Re: Nillumbik Shire Council's submission regarding the Yan Yean Road Upgrade Stage 2 Environmental Effects Statement

YAN YEAN ROAD UPGRADE STAGE 2 ENVIRONMENTAL EFFECTS STATEMENT SUBMISSION

FIGURE 5.46: VIEWPOINT C - YAN YEAN ROAD ALONGSIDE YARRAMBAT GOLF COURSE, LOOKING SOUTH - PROPOSED - YEAR 1 NOTE: DESIGN IS FOR ILLUSTRATIVE PURPOSES ONLY AND SUBJECT TO CHANGE

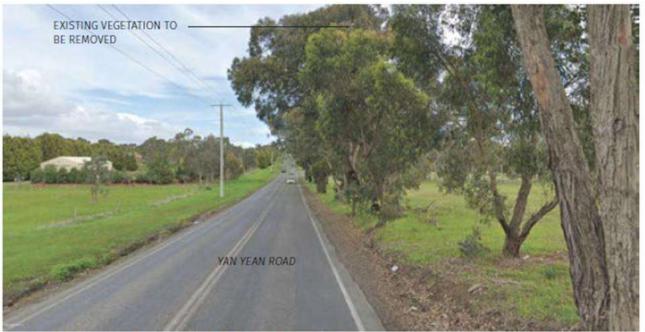
Document Reference	EES Description	Council's Concern/ Comment	Proposed Action
Public Acquisition Overlay	Public Acquisition Overlay impacts: Yarrambat Park Golf Course	Widening Yan Yean Road will result in a 25-metre encroachment into the Yarrambat Park Golf Course. As the owner of the golf course, Council	If the Planning Panel supports MRPV's proposed fence between the golf course and Yan Yean Rd, include EPRs: "MRPV to:
		needs to be satisfied that the risk of golf balls hitting cars or pedestrians on Yan Yean Rd is understood and mitigated. Options considered by MRPV include the installation of a 30-36 metre-high and 360 metre-long fence or realignment of the golf course. Council's preference is for neither of these options and this has aspect not yet been resolved (a golf ball trajectory study is currently underway).	Design and install a fence that minimises impacts on fauna, including design consideration of minimum required length and height, whether a 'louvre'-type fence would be suitable, and adopt the measures in the Swift Management Plan (page 33) of a tensioned fence of knotted or woven braided mesh between 15*15mm and 25*25mm that is

Council's concern includes:	planted with shrubs and small trees."
		 High fencing will have impacts on bird movements, including but not limited to Swift Parrot movements (Swift Parrots fly at the height of trees, roughly 10 to 15 metres, and a 30 to 36 metre-high fence will cause a significant risk to the species). The proposed fencing will alter and restrict the movement of ground species such as kangaroos, which are able to jump over the current fence, and echidnas, for example, which are able to pass under the current fence. Council considers that associated impacts have not been adequately considered within the EES. The proposed fence will be a prominent feature out of keeping with the rural landscape. Requires an ongoing maintenance 	 Undertake three years of fauna monitoring after the project's completion to determine deaths and injuries to birds, bats and other fauna as a direct result of collision with the golf course fence, to contribute to the body of research on the impacts of the installation of such structures; provide copies to DELWP, Nillumbik and Whittlesea councils, and determine and undertake mitigation works if required." Incorporate the maximum possible screening planting into the landscape design along the golf course frontage."

obligation to Council. Also presents a risk to the Greyheaded Flying Fox, which has been recorded in the area. Would result in golf being played along a fairway that immediately 	If the Planning Panel supports realignment of the golf course, include EPRs: "MRPV to undertake revised golf course masterplan utilising a high-quality specialist golf
		abuts the proposed fence and the new roadway which would be a very different playing experience to that currently enjoyed.	course designer, in close consultation with Nillumbik Shire Council, and undertake mitigation works at MRPV's cost."
		Golf course realignment Realigning the championship golf course is a major, long-term and costly exercise requiring significant	"MRPV compensate Council and the golf course operator for all business losses attributed to the gold course redesign,

Document Reference	EES Description	Council's Concern/ Comment	Proposed Action
		works and a redesign of the masterplan. The championship golf course is popular and renowned for its design and therefore any realignment could compromise the operation of the golf course and have potential business viability impacts for the operators and Council.	including all costs to reconstruct the golf course."
